## United States Patent and Trademark Office

APPLICATION NO.	FILING DATE	FIRST NAMED INVENTOR	ATTORNEY DOCKET NO.	CONFIRMATION NO.
10/568,631	02/16/2006	Christoph Buchta	22515104123	7588
7590 01/02/2008 MR. ROBERT W. ASHER			EXAMINER	
CLARK HILL 500 WOODWARD AVENUE SUITE 3500			REDMAN, JERRY E	
			ART UNIT	PAPER NUMBER
	DETROIT, MI 48226-3435		3634	
		·	MAIL DATE	DELIVERY MODE
			01/02/2008	PAPER

1	Application No.	Applicant(s)				
	10/568,631	BUCHTA, CHRISTOPH				
Office Action Summary	Examiner	Art Unit				
	Jerry Redman	3634				
The MAILING DATE of this communication appears on the cover sheet with the correspondence address						
Period for Reply A SHORTENED STATUTORY PERIOD FOR REPLY IS SET TO EXPIRE 3 MONTH(S) OR THIRTY (30) DAYS,						
WHICHEVER IS LONGER, FROM THE MAILING DA  - Extensions of time may be available under the provisions of 37 CFR 1.13 after SIX (6) MONTHS from the mailing date of this communication.  - If NO period for reply is specified above, the maximum statutory period w  - Failure to reply within the set or extended period for reply will, by statute, Any reply received by the Office later than three months after the mailing earned patent term adjustment.

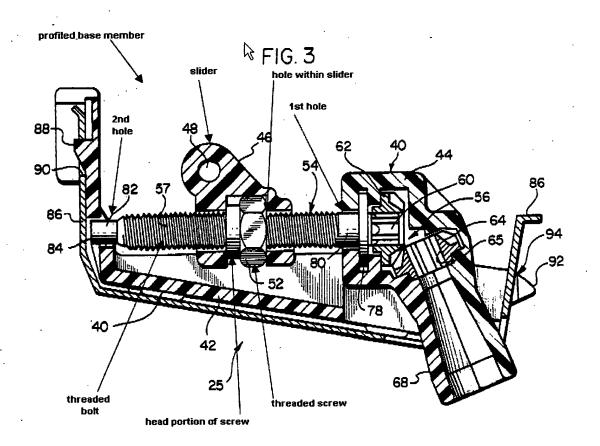
As best understood, claims 1-2 are further rejected under 35 U.S.C. 102(b) as being anticipated by Lisak et al. (4,956,942). As shown in detail below, by Lisak et al. (4,956,942) disclose an adjusting comprising a profiled base element (25) positionable on a lower section of a vehicle door (10) and provided with a first elongate hole and second elongate hole (see figure below), a slider (46) slidably moveable within the profiled base element (25) and provided with a hole, a screw (52) having a head portion (see figure below), and a threaded bolt (54) extending within the holes.
